## DRAFT MOUND BRANCH TMDL PUBLIC COMMENTS

Public Notice October 29, 2009 – December 14, 2009

Mound Branch WBID # 1300

Subject: Draft Mound Branch Total Maximum Daily Load Report

Figure 1. Calibration run. Sensitivity runs implies insignificant differences.

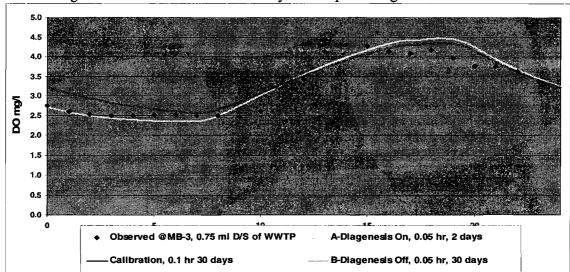
Comment #6: Sediment Oxygen Demand is not mechanistically simulated in the TMDL model.

The purpose of the TMDL model allocation run is to establish WLAs for CBOD and nutrients that will result in attainment of WQS downstream of the City of Butler's WWTF. The model allocation run discounts the effects of SOD, hence a minimal SOD flux was prescribed. However, if the WLA results are desired to be more conservative, mechanistically modeling the SOD would likely result in more stringent CBOD limits, lower than what is indicated in the TMDL. Recalibration of the QUAL2K model is not necessary and would not change the results of the analysis.

A 30-40 percent SOD bottom coverage is a less conservative assumption. What is described in the 2003 water quality report is the stream condition at the sampling site near the U.S. Highway 71 bridge crossing approximately 1 mile below the City of Butler's WWTF. Results of additional sensitivity analysis are shown in the following figures:
